# Nomad

# SERVICE BULLETIN

## FLIGHT CONTROLS — FLAP MICROSWITCHES — INCORPORATION OF MOD N835 (N22) & N874 (N24)

# NMD-27-50

**Figure 1 Existing Cam/Microswitch Assembly (Post-Mod N46 or N124)**

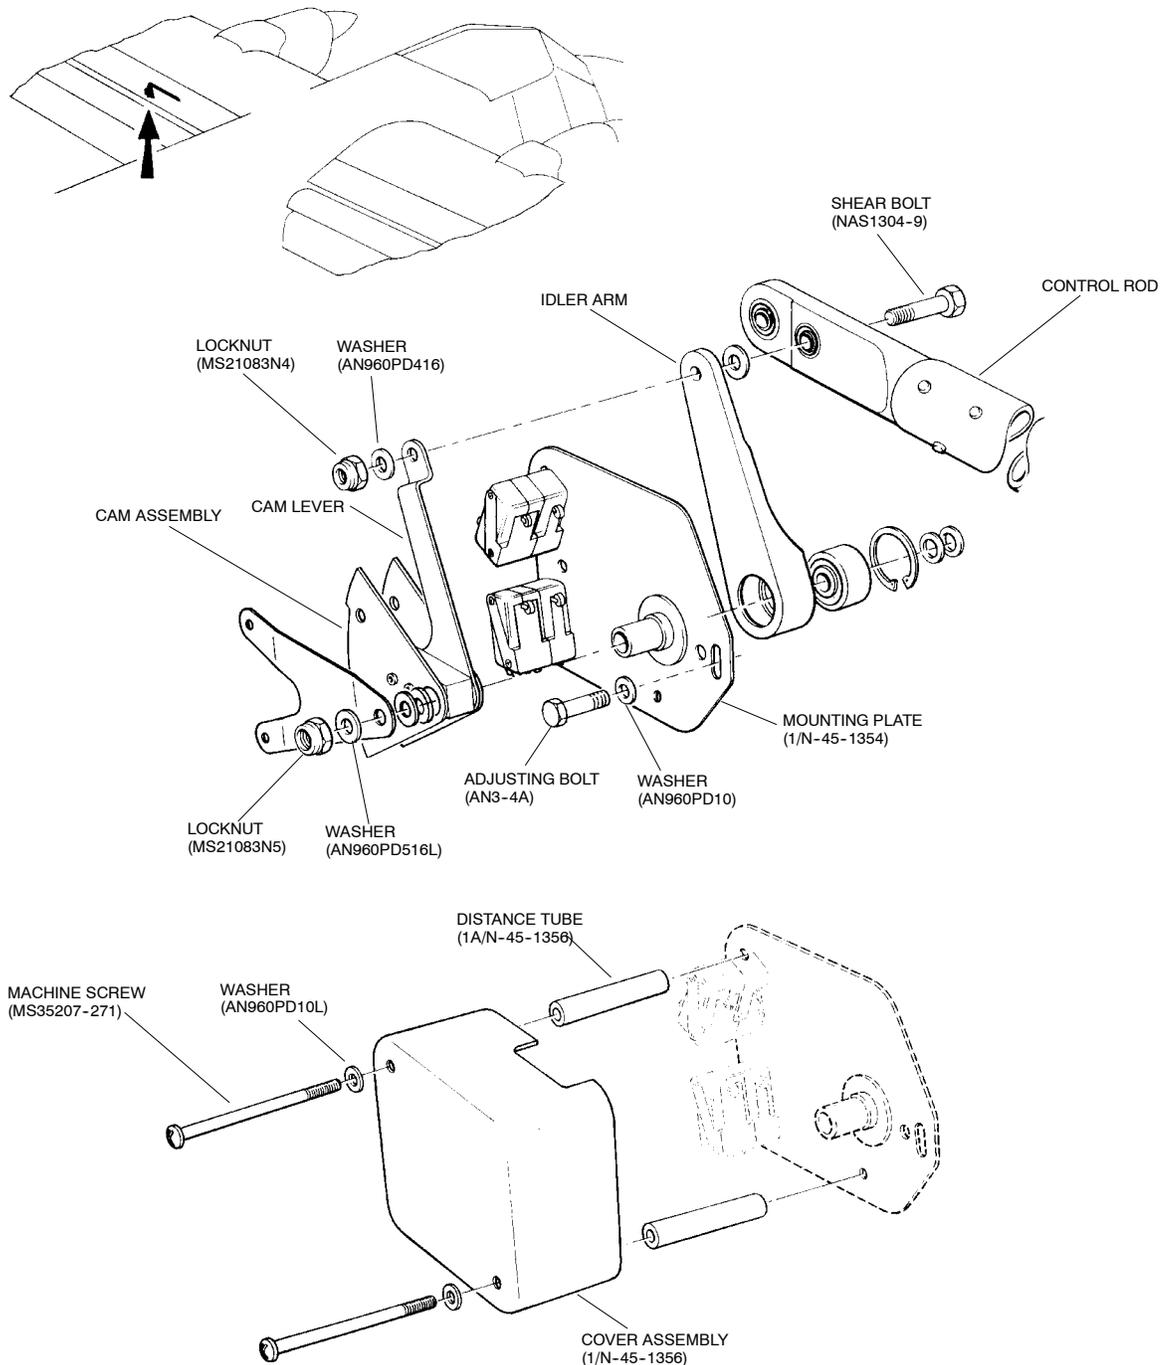
- (1) Apply external power, set the flap circuit breakers and the battery switch to ON.
- (2) Ensure cabin doors are shut and extend the flaps (Ref MM Chap 27-50-00).
- (3) Set the battery switch to OFF, trip the flap circuit breakers and remove external power.
- (4) Gain access to the cam/microswitch assembly (Ref Fig 1) at wsta 62.528 by opening the appropriate LH wing trailing edge doors.
- (5) **Post-Mod N46 (N22 Series) or N124 (N24 Series):** Remove the moulded plastic cover by loosening the two screws (Ref MM Chap 27-50-03, Fig 202, Sheet 2). Retain Cover Assembly 1/N-45-1356 (screws, washers and distance pieces to be replaced if damaged, Ref IPC Chap 27-50-02. Fig 2).

- (6) **Post-Mod N608:** Remove the plastic bag around the outboard end of the moulded cover and wiring loom (Ref MM Chap 27-50-03, Fig 203), and remove the moulded plastic cover by loosening the two screws (Ref MM Chap 27-50-03, Fig 202, Sheet 2). Retain Cover Assembly 1/N-45-1356 (screws, washers and distance pieces to be replaced if damaged, Ref IPC Chap 27-50-02 Fig 2).

- (7) Disconnect the electrical connections at the microswitches, discard wires (idents C12E22 and C13D22) that connect between microswitches.
- (8) Remove and discard shearbolt (NAS1304-9), locknut (MS21083N4) and washer (AN960PD416) from the cam lever and idler arm attachment to the flap control rod.

- (9) Remove and discard the locknut (MS21083N5) and washer (AN960PD516L) (**Post-Mod N46 or N124**) from the flap idler arm mounting bolt.
- (10) Remove and retain the adjustment bolt (AN3-4A) and remove and discard washer (AN960PD10).
- (11) Withdraw the cam assembly and mounting plate from the wing.

**Figure 2 Cam/Microswitch Assembly (Mod N835)**

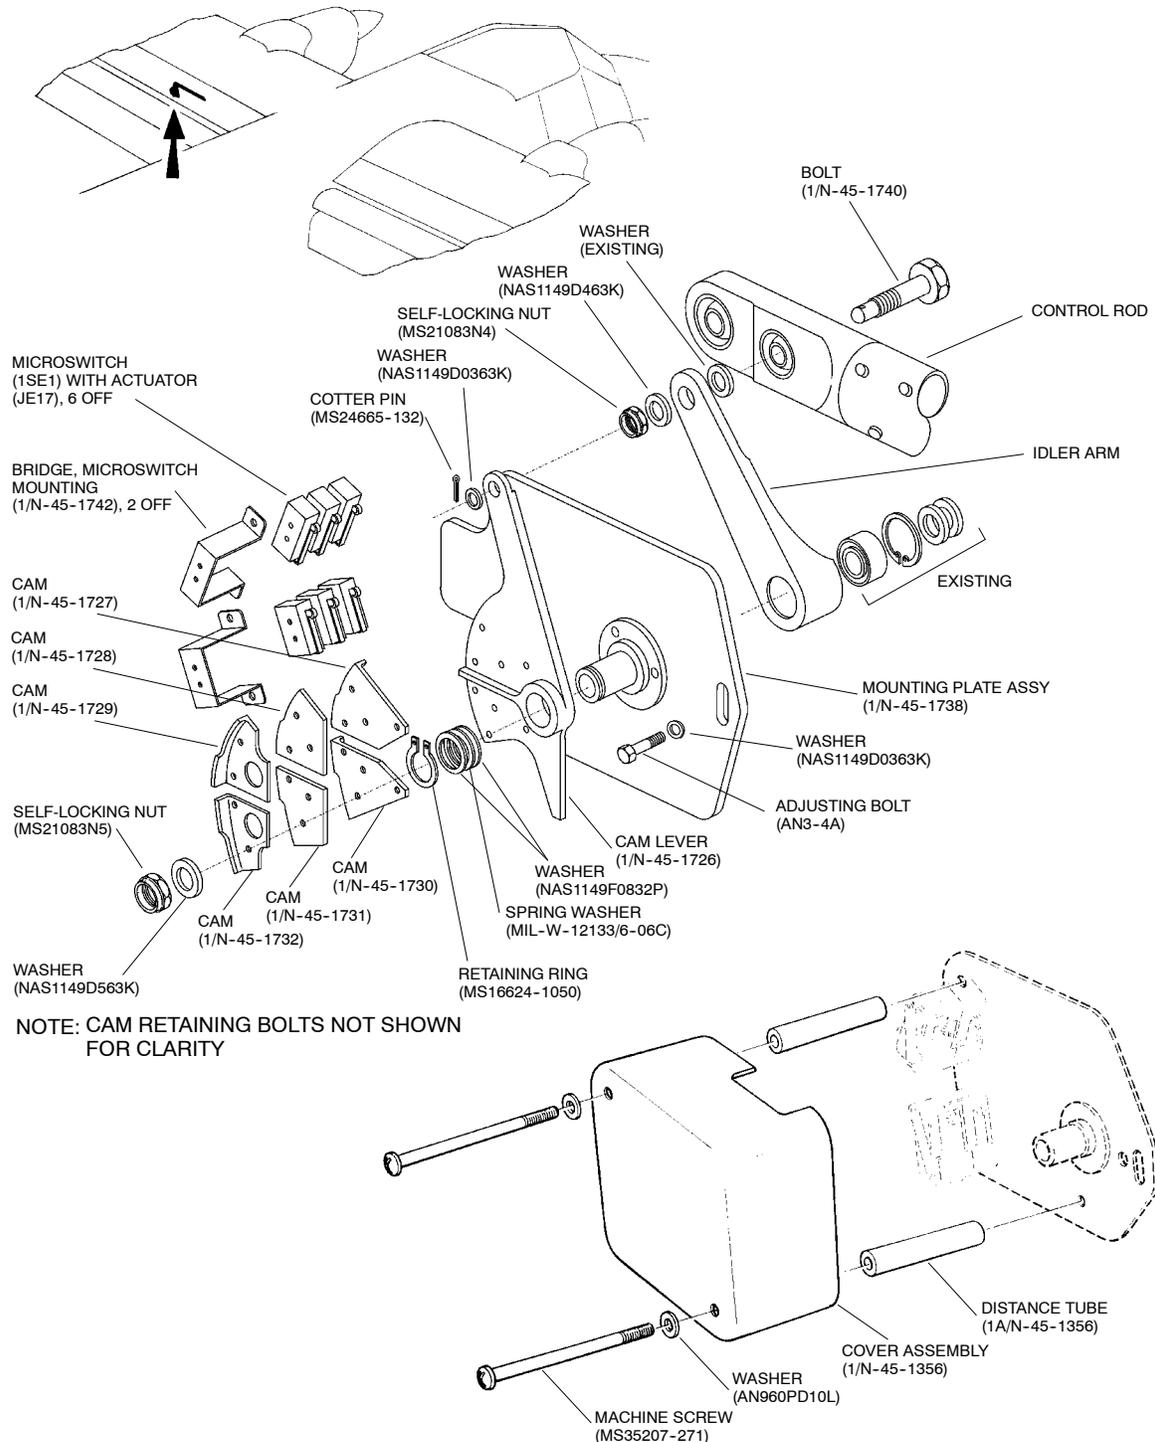
Cam/Microswitch assembly (1/N-45-1724) is supplied fully assembled with cams set. However, it is recommended that prior to installation on the wing correct activation of the microswitches be checked as follows (Ref Figs 2, 3 and 4):

- (1) Using a Multimeter, check microswitches B2, B1 and D as follows:
  - (a) Hold the cam lever fully counter-clockwise.
  - (b) Insert a 0.060 inch feeler gauge between microswitch B2 roller and its actuating cam.
  - (c) Confirm microswitch activates when the feeler gauge is inserted, and deactivates when the feeler gauge is withdrawn.
  - (d) Repeat steps (a) to (c) for microswitches B1 and D.
- (2) If an adjustment is necessary proceed as follows:
  - (a) Slacken only those screws securing the cams needing adjustment.
  - (b) With cam lever rotated fully counter-clockwise place a 0.060 inch feeler gauge between the microswitch roller and the lower step of the cam. Slide cam on the lever until the

switch just activates and torque tighten screws to 5-10 lb in. Recheck microswitch activation of all three cams in the group and adjust as required.

- (3) Using a Multimeter, check microswitches A2, A1 and C as follows:
  - (a) Hold the cam lever fully clockwise.
  - (b) Insert a 0.060 inch feeler gauge between microswitch A2 roller and its actuating cam.
  - (c) Confirm microswitch activates when the feeler gauge is inserted, and deactivates when the feeler gauge is withdrawn.
  - (d) Repeat steps (a) to (c) for microswitches A1 and C.
- (4) If an adjustment is necessary proceed as follows:
  - (a) Slacken only those screws securing the cam needing adjustment.
  - (b) With cam lever rotated fully clockwise, place a 0.060 inch feeler gauge between the microswitch roller and the lower step of the cam. Slide cam on the lever until the switch just activates and torque tighten screws to 5-10 lb in. Recheck microswitch activation of all three cams in the group and adjust as required.

- If the cam segment holes are enlarged, ensure the part is free from all burrs and sharp edges. Touch up exposed surfaces with Alodine.
- (5) Pass special bolt (1/N-45-1740) through flap control rod and idler arm and secure with new locknut (MS21083N4) and washer (NAS1149D463K), torque tighten to 30-40 lb in.

- (6) Fit cam/microswitch assembly in place on the mounting bolt with the end of cam lever extending over the special flap control rod bolt (1/N-45-1740), securing to mounting bolt with new locknut (MS21083N5) and washer (NAS1149D563K) and to the special bolt with washer (NAS1149D0363K) and split pin (MS24665-132), torque tighten locknut to 60-85 lb in.

- (7) Secure mounting plate to aircraft structure using retained adjusting bolt (AN3-4A) and new washer (NAS1149D0363K). Do not fully tighten bolt.
  - (8) Apply external power, set the flap circuit breakers and the battery switch to ON. Raise the flaps to 22°.

- (11) Rotate the cam/microswitch assembly mounting plate counter-clockwise to ensure release of both A1 and A2 microswitches. Then rotate the mounting plate clockwise until the either microswitch A1 or A2 just activates. Tighten the adjusting bolt to 15-20 lb in.

Figure 4 Mod N835 (N22) Microswitch Positions and Schematic Wiring Diagram

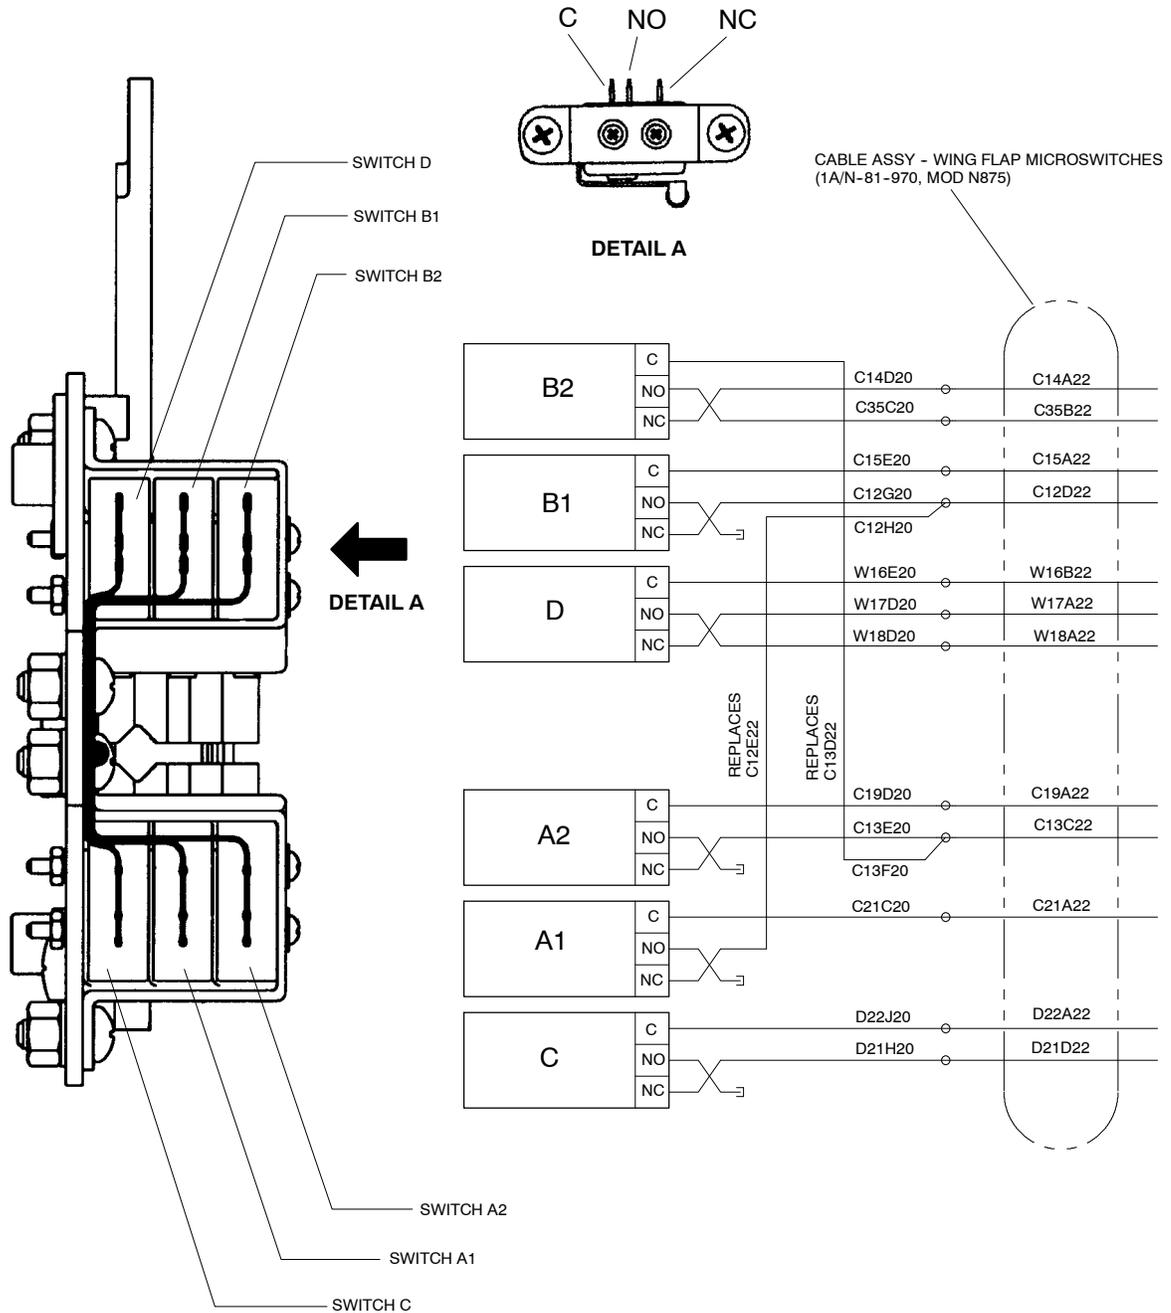
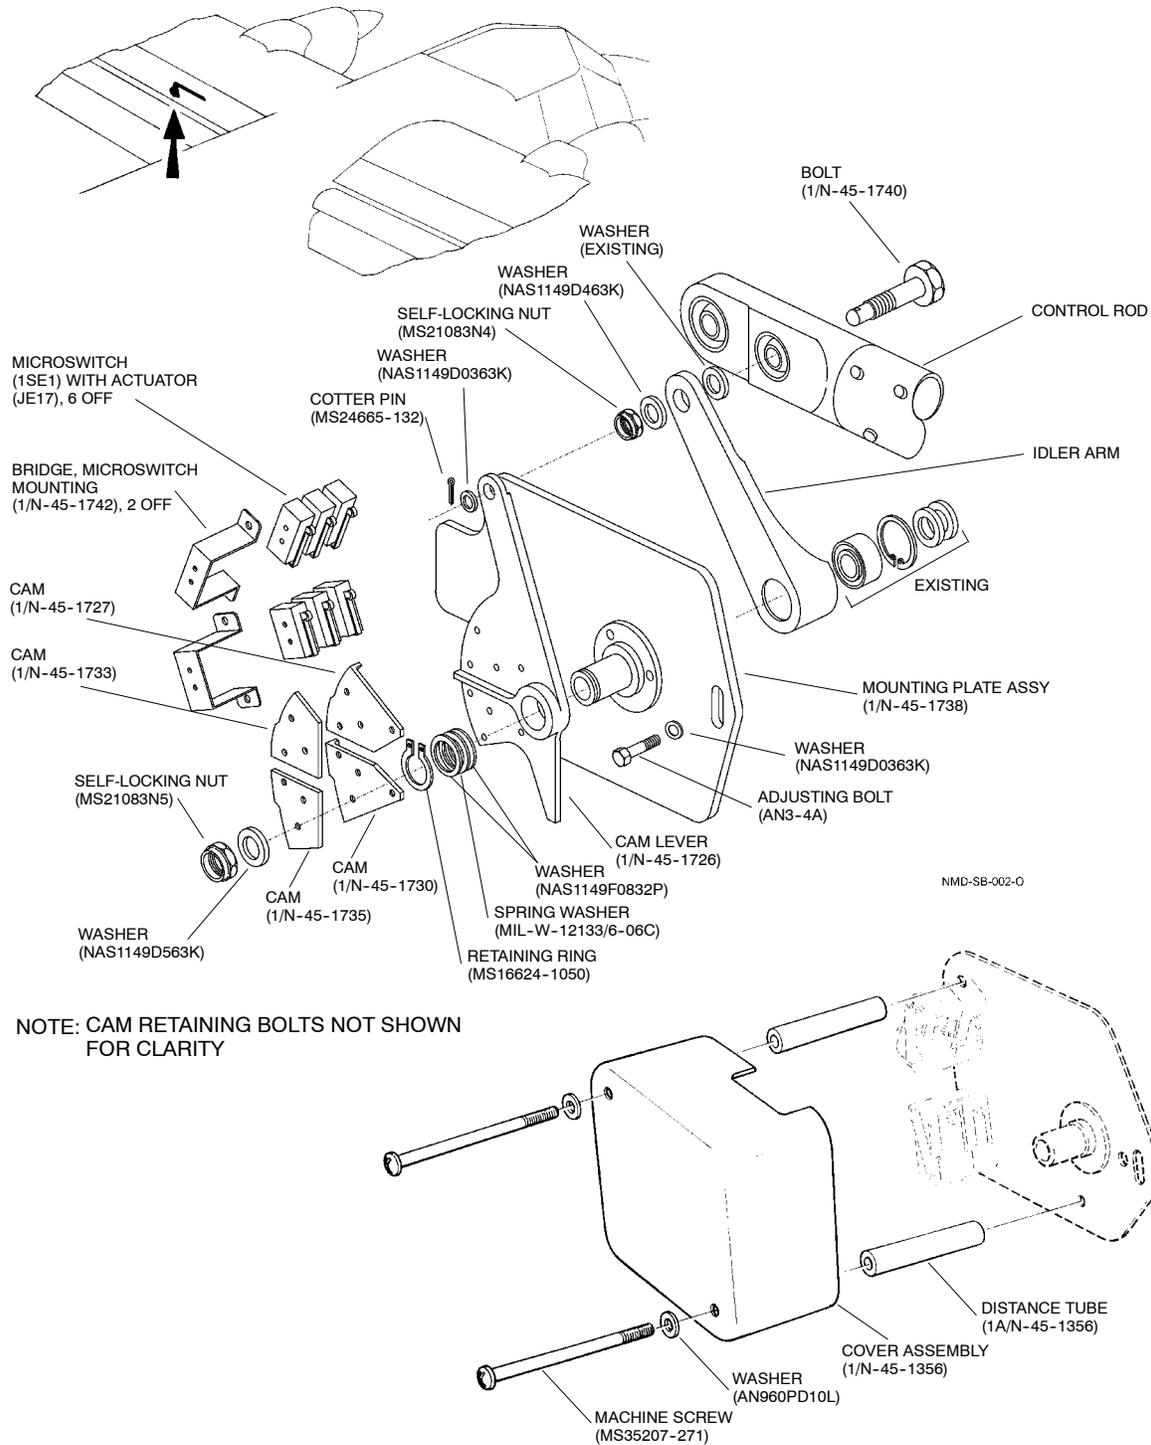
- (a) Identify leads from microswitches (Ref Fig 4).
- (b) Cut off crimped lugs (MS25036-148) from the aircraft cable wire ends and connect to the external wire leads from microswitches (Ref Fig 4) using solder sleeves (M83519/1-2) or crimp splices (M81824/1-2).

- (c) Unused wire leads from microswitches (Ref Fig 4) to be capped using insulated wire caps (324484 AMP) and suitably stowed in a separate bundle.
  - (d) Secure cable to mounting plate with clip (NX3), screw (MS35206-246), nut (MS21044N08) and two washers (NAS1149DN832K). Secure aircraft wire bundle using waxed nylon cordage (WN25).

**Figure 5 Cam/Microswitch Assembly (Mod N874)**

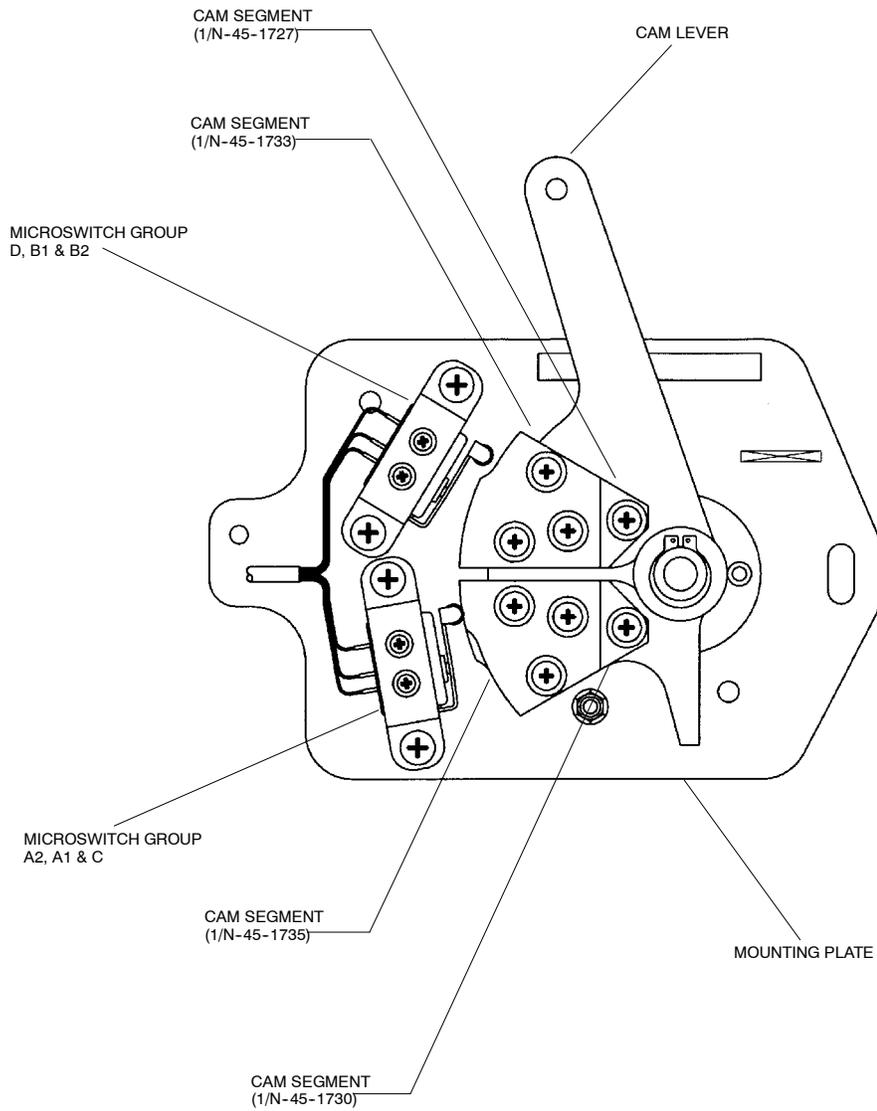
Cam/Microswitch assembly (1/N-45-1725) is supplied fully assembled with cams set. However, it is recommended that prior to installation on the wing correct activation of the microswitches be checked as follows (Ref Figs 5, 6 and 7):

Microswitches B2 and A2 are not used, and there are only two cams per group to check/adjust.

- (1) Using a Multimeter, check microswitches B1 and D as follows:
  - (a) Hold the cam lever fully counter-clockwise.
  - (b) Insert a 0.060 inch feeler gauge between microswitch B1 roller and its actuating cam.
  - (c) Confirm microswitch activates when the feeler gauge is inserted, and deactivates when the feeler gauge is withdrawn.
  - (d) Repeat steps (a) to (c) for microswitch D.
- (2) If an adjustment is necessary proceed as follows:
  - (a) Slacken only those screws securing the cam needing adjustment.

- If the cam segment holes are enlarged, ensure the part is free from all burrs and sharp edges. Touch up exposed surfaces with Alodine.
- (5) Pass special bolt (1/N-45-1740) through flap control rod and idler arm and secure with new locknut (MS21083N4) and washer (NAS1149D463K), torque tighten to 30–40 lb in.

- (6) Fit cam/microswitch assembly in place on the mounting bolt with the end of cam lever extending over the special flap control rod bolt (1/N-45-1740), securing to mounting bolt with new locknut (MS21083N5) and washer (NAS1149D563K) and to the special bolt with washer (NAS1149D0363K) and split pin (MS24665-132), torque tighten locknut to 60–85 lb in.

- (7) Secure mounting plate to aircraft structure using retained adjusting bolt (AN3-4A) and new washer (NAS1149D0363K). Do not fully tighten bolt.
  - (8) Apply external power, set the flap circuit breakers (ACT and CONT) and the battery switch to ON. Raise the flaps to fully UP.

- (12) Rotate the cam assembly mounting plate counter-clockwise to ensure release of A1 microswitch. Then rotate the mounting plate clockwise until the A1 microswitch just activates. Tighten the securing bolt to 15–20 lb in.

Figure 7 Mod N874 (N24) Microswitch Positions and Schematic Wiring Diagram

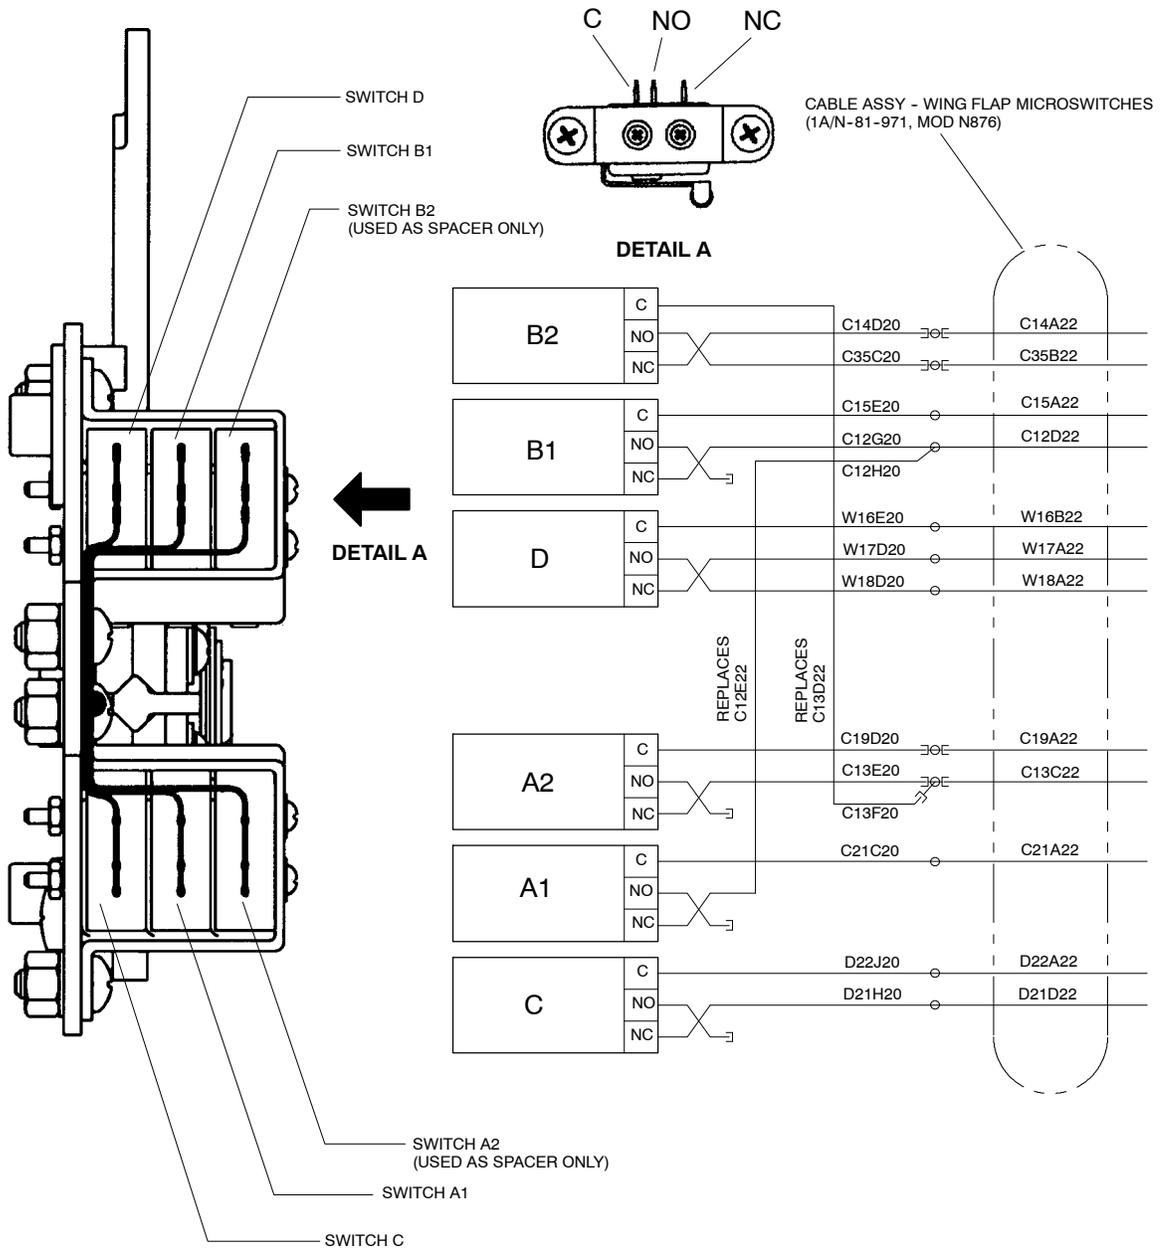
- (a) Identify leads from microswitches (Ref Fig 7).
- (b) Cut off crimped lugs (MS25036-148) from the aircraft cable wire ends and connect to the external wire leads from microswitches (Ref Fig 7) using solder sleeves (M83519/1-2) or crimp splices (M81824/1-2).

- (c) Unused wire leads from microswitches and aircraft wire bundle (Ref Fig 7) to be capped using insulated wire caps (324484 AMP) and suitably stowed in separate bundles.
